# Service Bulletin

Bulletin No.: PI1365

**Subject:** HVAC Mode Setting Adjustments Not Available and/or Clicking Noise Heard Under Instrument Panel When Switching HVAC Modes

**Models:** 2015 Chevrolet Equinox  
2015 GMC Terrain  
Equipped with HVAC Systems (RPOs C67, C68)  
Vehicles Built Prior to August 8, 2014

3998429

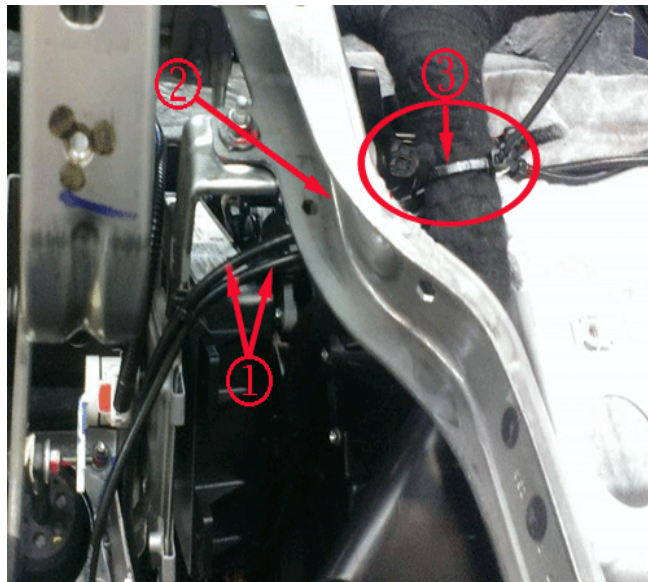
Some customers may comment on a clicking noise heard under the instrument panel when switching HVAC modes or HVAC System mode switching may not operate as expected.

This may be due to the routing of the OnStar cables (1), restricting the travel of the HVAC mode door (2).

Securely tie strap both OnStar cables to the IP harness away from the HVAC mode door following the procedure below:

3. Take both OnStar cables (1) and pull away from the HVAC mode door while routing under the instrument panel support (2) and tie strap them to the instrument panel harness (3). 3997522
4. Reinstall the driver knee bolster reinforcement.
5. Reinstall the instrument panel insulator panel.
6. Re-perform the HVAC system check to confirm that the HVAC system operation is fully functional as expected.
